**STAFF REPORT**  
(One-Step Final Plat)

**CASE NUMBER:** SUB 2003-29 -- BRIGHTON COURTS ADDITION

**SUB 2003-29 -- One-Step Final Plat of BRIGHTON COURTS ADDITION**  
**April 17, 2003 - Page 2**

**VICINITY MAP**

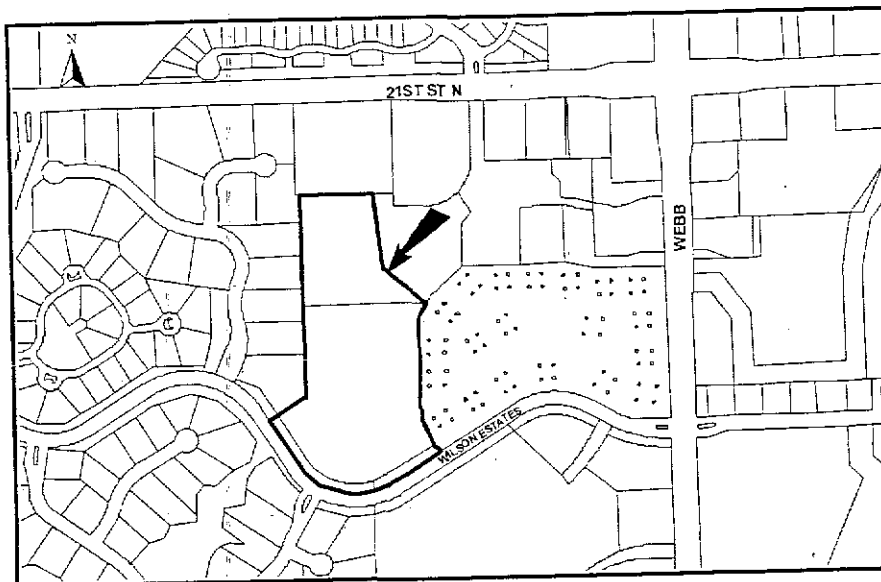
- A. The applicant shall guarantee the extension of sanitary sewer and City water to serve the lots being platted. City Engineering needs to comment on the need for other guarantees or easements.

- C. City Engineering needs to comment on the status of the applicant's drainage plan.
- D. Traffic Engineering needs to comment on the 32-ft right-of-way width platted for the internal street. The Subdivision Regulations limit 32-ft narrow local streets to 24 lots.

- H. County Surveying has noted that several centerline dimensions need added.
- I. County Surveying has noted that dimensions on Reserve "A", Lot 32 and Lot 18 need added.

- M. City Fire Department needs to comment on the street length of the internal street (1100 feet). The Subdivision Regulations limit urban cul-de-sacs to 800 feet in length unless an emergency access easement is proposed. City Fire Department has requested a second street connection to Wilson Estates Parkway located between Lots 32 and 33, Block 1. GIS has requested that this street be named N. Cypress.

- N. Since this plat proposes the platting of narrow street right-of-way with adjacent "15-foot street drainage and utility easements", a restrictive covenant shall be submitted which calls out restrictions for lot-owner use of these easements. Retaining walls and change of grade shall be prohibited within these easements as well as fences, earth berms and mass plantings.

- Q. GIS has requested that the new street be named Paddock Green. The loop street at the north should be named Paddock Green Cir and the other cul-de-sacs emanating from Paddock Green should be named Paddock Green Ct.
